February 16, 2024

PCN
Change of blister tape cavity for CeraLink LP capacitors

1. ID No. 015/T128		**2. Date of announcement** February 16, 2024	
3. Product / product group CeraLink LP capacitor series B58031U* (J-style)	**Old ordering code** B58031U5105M062 B58031U7504M062 B58031U9254M062	**New ordering code** No change	**Customer part number** -

Details of change

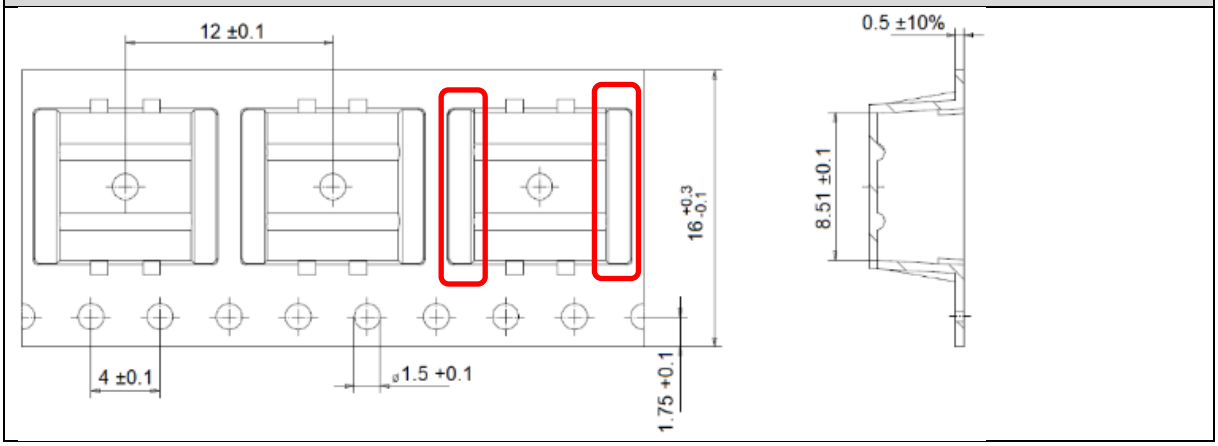
To further optimize the production handling, the blister tape cavity of the CeraLink low profile (LP) capacitor series B58031U* will be modified by additional shallow openings on the sides of the CeraLink terminals. There will be no impact on the appearance, function, processability, materials, or production process of the products.

4. Description of change Change of blister tape cavity as shown in details of change.			
5. Effect on the product or for the customer (benefit, quality, specification, lead time) Except the described changes there will be no other effects in appearance, function, processability, materials and production process on the affected products.
